SUNDRY NOTICES AND REPORTS ON WELLS
Do not use this form for proposals to drill or to re-enter an abandoned well. Use form 3160-3 (APD) for such proposals.

Devon Energy Production Co., LP respectfully requests approval to use a multibowl wellhead on the Thistle Unit 30H.

Thistle Unit 30H- APD DRILLING PLAN
 Updated 10/16/15 – Target Formation Change

CONDITIONS OF APPROVAL

PRIMARY MODE

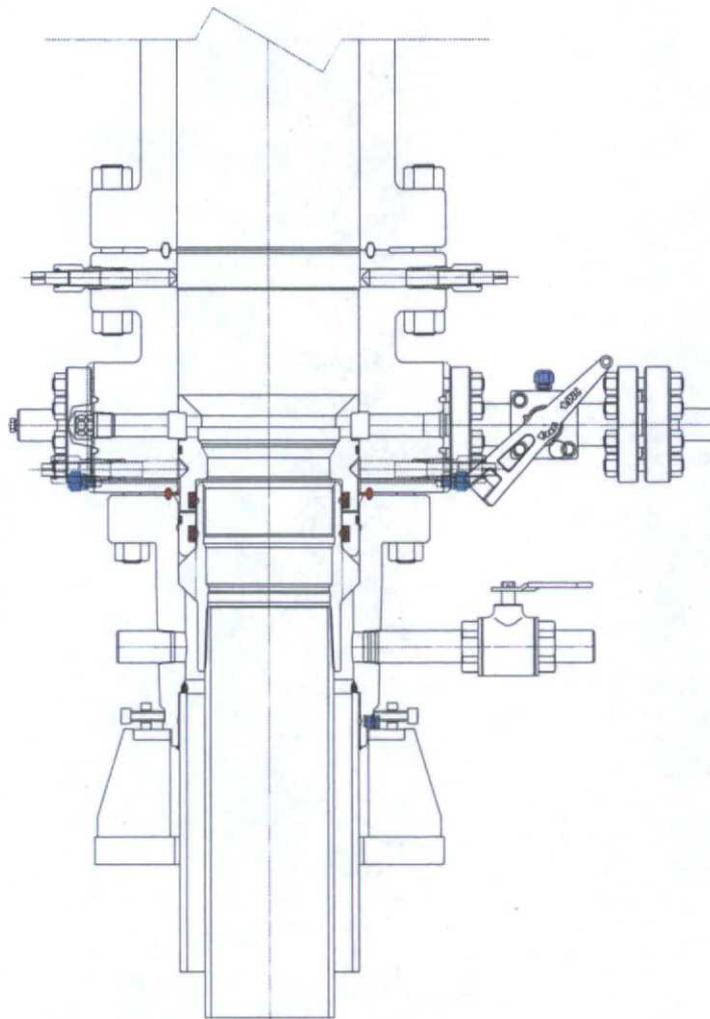
Please see the attached revised verbiage for the Pressure Control Equipment within the Drill Plan and an updated schematics.

Devon may use a multi-bowl wellhead assembly. This assembly will only be tested when installed on the surface casing. Minimum working pressure of the blowout preventer (BOP) and related equipment (BOPE) required for drilling below the surface casing shoe shall be 3000 (3M) psi.

- Wellhead will be installed by wellhead representatives.
- If the welding is performed by a third party, the wellhead representative will monitor the temperature to verify that it does not exceed the maximum temperature of the seal.

- Wellhead representative will install the test plug for the initial BOP test.
- The wellhead company will install a solid steel body pack-off to completely isolate the lower head after cementing intermediate casing. After installation of the pack-off, the pack-off and the lower flange will be tested to 3M, as shown on the attached schematic. Everything above the pack-off will not have been altered whatsoever from the initial nipple up. Therefore the BOP components will not be retested at that time.

3. **Operator has proposed a multi-bowl wellhead assembly. This assembly will only be tested when installed on the surface casing. Minimum working pressure of the blowout preventer (BOP) and related equipment (BOPE) required for drilling below the surface casing shoe shall be 3000(3M) psi.**

- a. **Wellhead shall be installed by manufacturer's representatives, submit documentation with subsequent sundry.**
 - b. **If the welding is performed by a third party, the manufacturer's representative shall monitor the temperature to verify that it does not exceed the maximum temperature of the seal.**

- c. **Manufacturer representative shall install the test plug for the initial BOP test.**
 - d. **Operator shall perform the intermediate casing integrity test to 70% of the casing burst. This will test the multi-bowl seals.**

- e. **If the cement does not circulate and one inch operations would have been possible with a standard wellhead, the well head shall be cut off, cementing operations performed and another wellhead installed.**

CONTINGENCY MODE

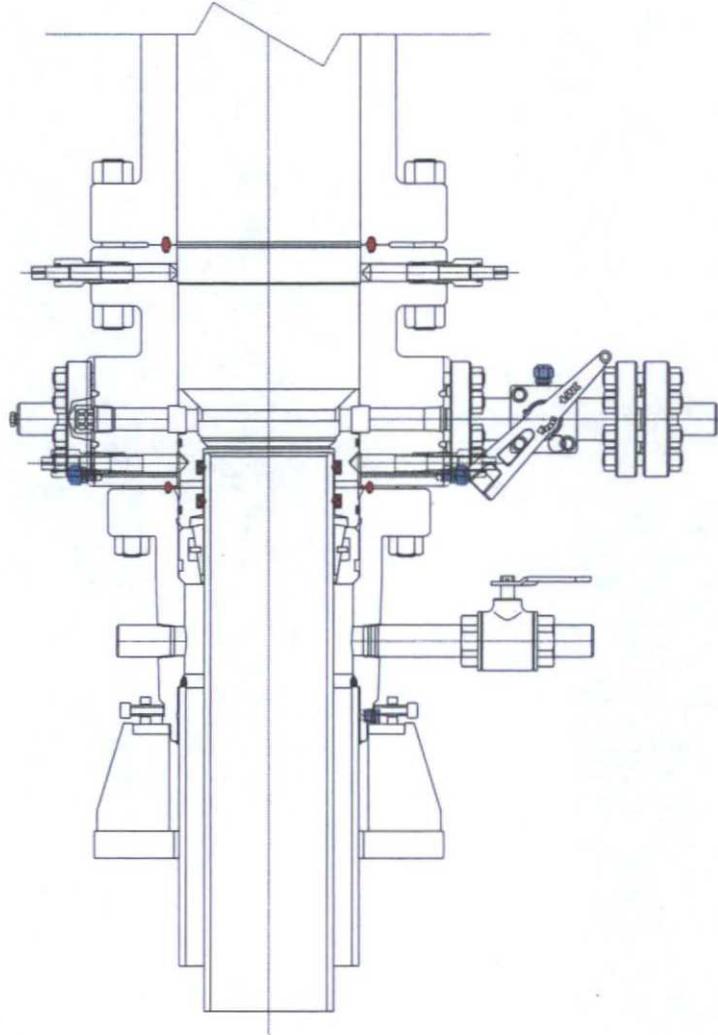
- If the cement does not circulate and one inch operations would have been possible with a standard wellhead, the well head will be cut and top out operations will be conducted.
